APPLICATION FOR CERTIFICATE OF APPROPRIATENESS (COA)

Building address 13 W Manton Street

Historic Board Presentation

LOCATION: 13 W. MORTON ST.

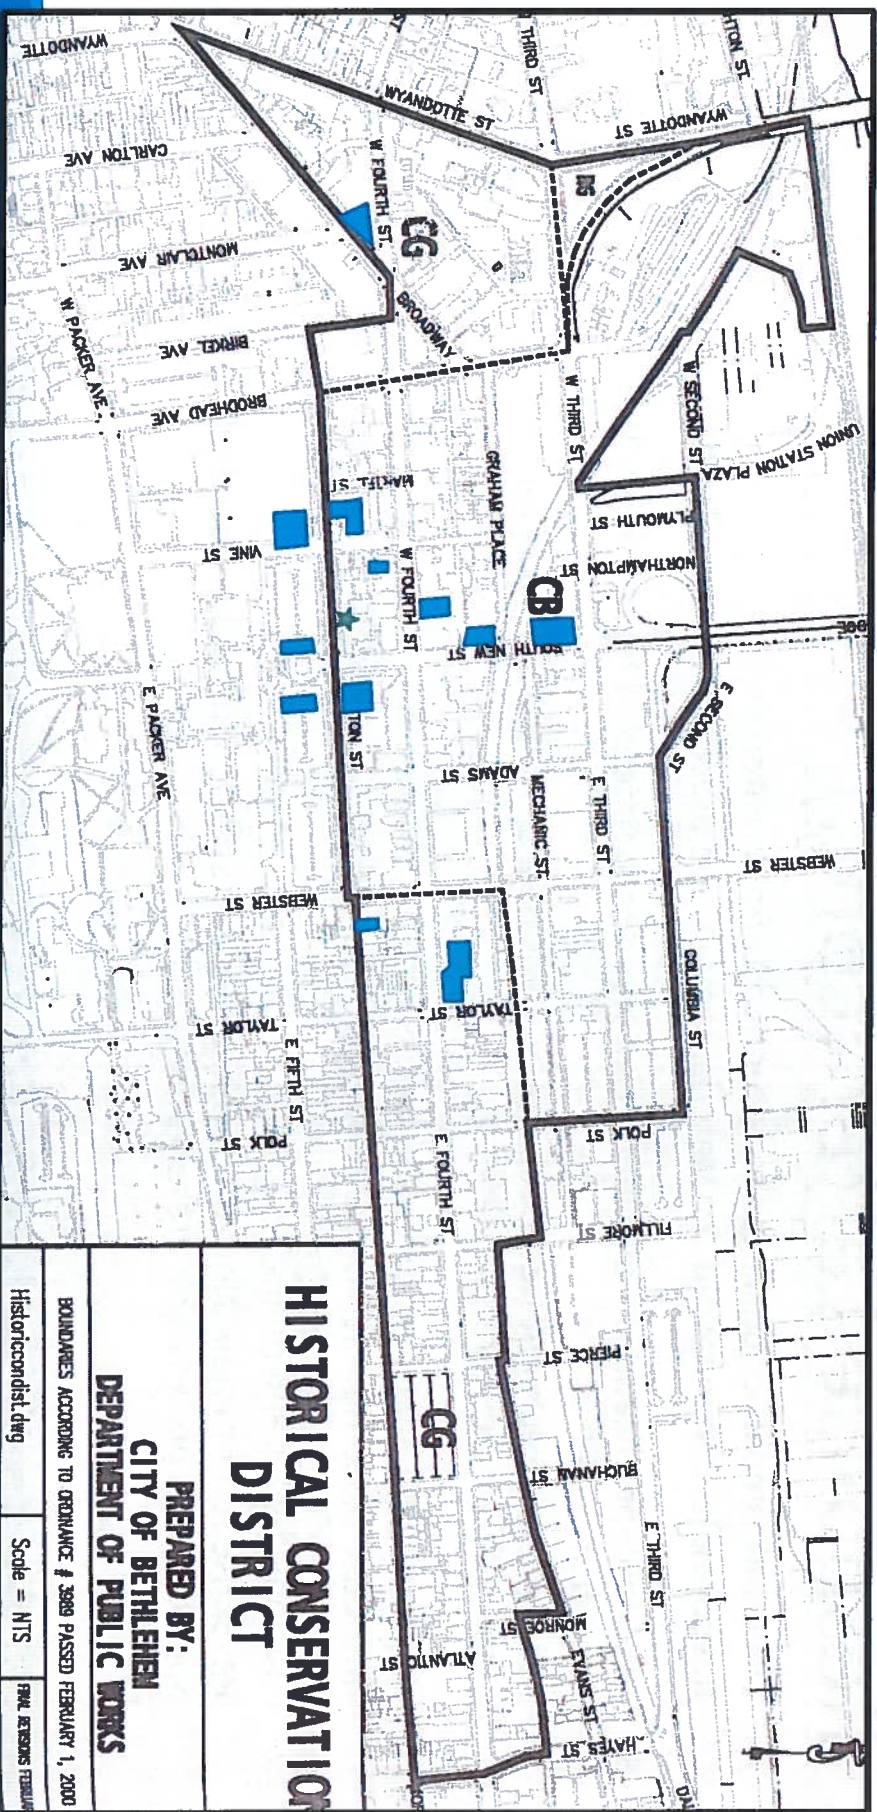
4. The blank east facade is not appropriate and should have recessed blind windows as required of other buildings where windows not permitted by code

- **Response to Comment No. 4:** The new designs includes recess windows to provide architectural textures to the east wall.
5. There should be no EIFS used on the projecting bay windows – all stucco should be cement based and smooth. Other materials might be considered such as fiber cement panels.

Scale Drawing of W. Morton St.

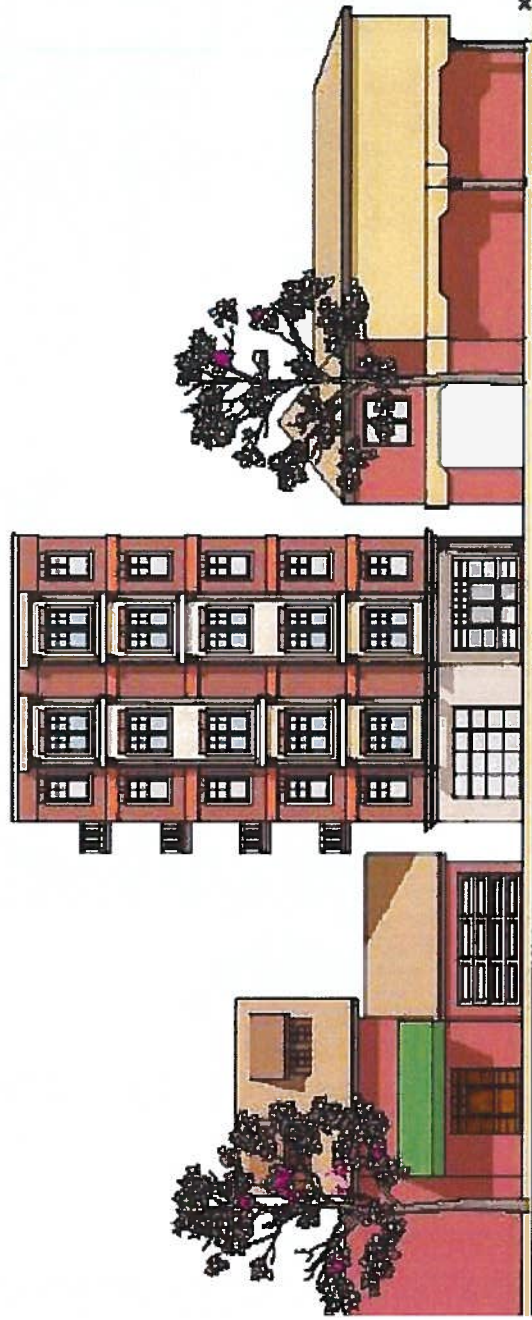
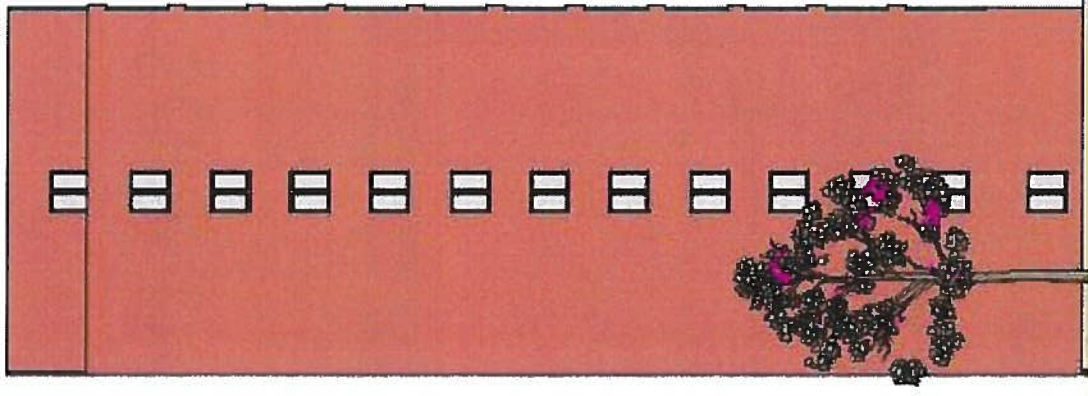
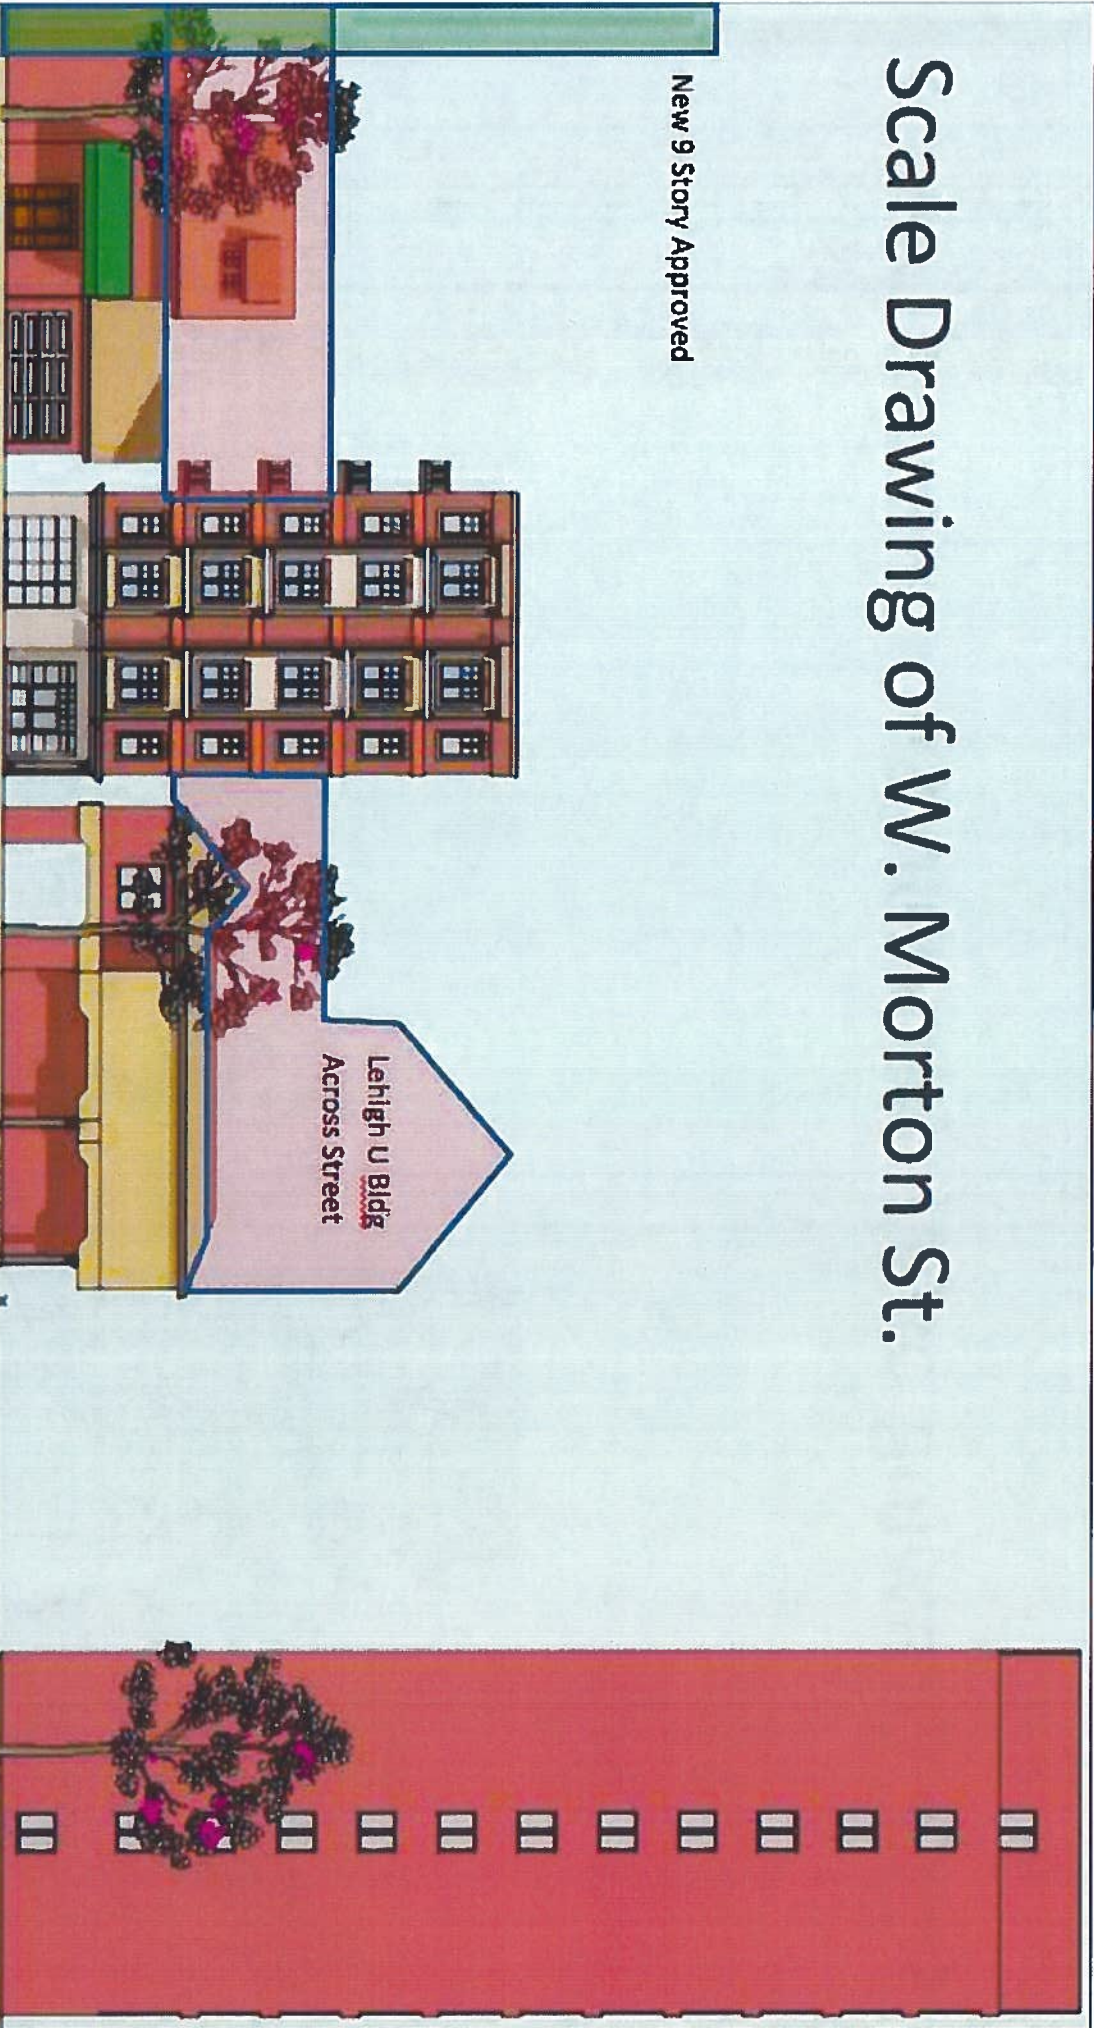
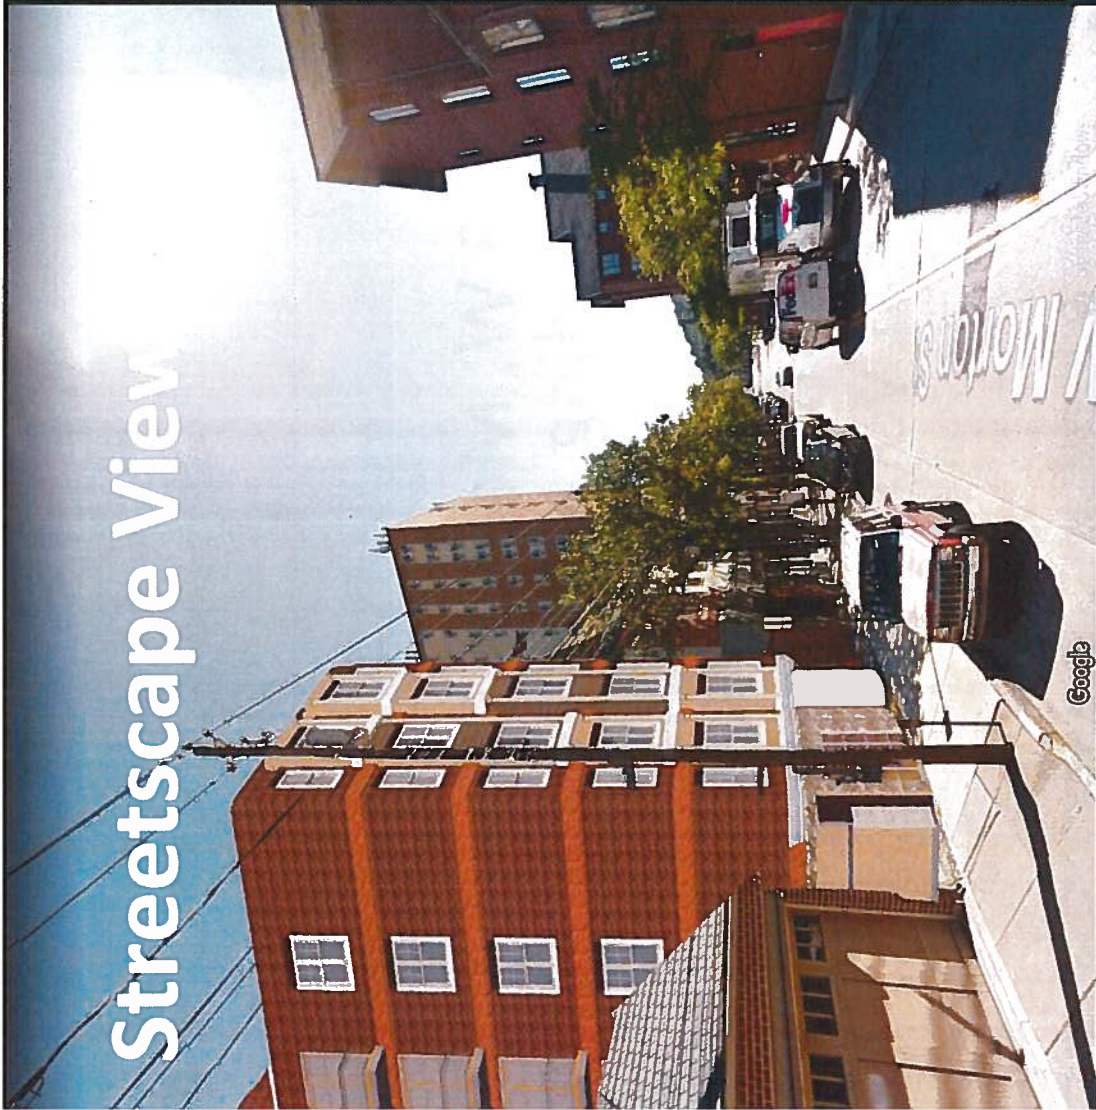
- **Response to Comment No. 5:** No EIFS will be utilized on this building. Matching Stucco cement based and smooth will be utilized.
6. Streetscape views should be required of the proposed building showing the surrounding buildings at actual height. These views are important to assess the impact on the historic district and pedestrians. A minimum of two are recommended.

- **Response to Comment No. 6:** Two streetscape views are provided. These shows how the proposed building blends well with the existing streetscape and neighborhood. We believe that the proposed building blends in well and will enhance the overall look of the existing streetscape.

Windows / Glass

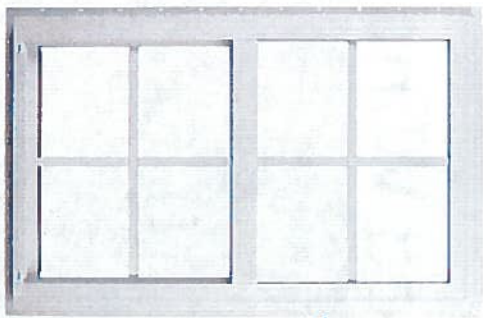
7. Material samples of brick, concrete, and storefront materials
 - **Response to Comment No. 7:** Material samples are provided. Please refer to presentation.
8. Window specifications – aluminum clad wood recommended for the upper levels, aluminum for the storefront level
 - **Response to Comment No. 8:** All windows will be aluminum clad wood for the upper levels and aluminum for the storefront level.
9. Window glass specifications – clear glass with no tint recommended
 - **Response to Comment No. 9:** All window glass will be clear, double pane, with no tint.
10. Balcony details and railings
 - **Response to Comment No. 10:** The balcony details and railing will match those in the neighborhood. Specifications provided on presentation.
